RYEFIELD ST., PEAKS ISL.

STATEMENT ACCOMPANYING APPLICATION FOR BUILDING PERMIT

Subject: Building permit for alterations of the dwelling at Ryefield Street, Peaks Island owned by Charles Scott (Assessor's # of 15,3575)

APPLICATION FOR PERMIT

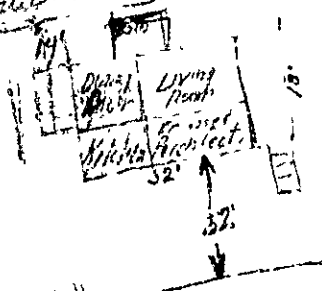
INQUIRY: Can small building be moved to front of this lot and used for small retail store?

ANSWER: No not allow in apt zone & considerable question if Board of Appeals has authority to grant.
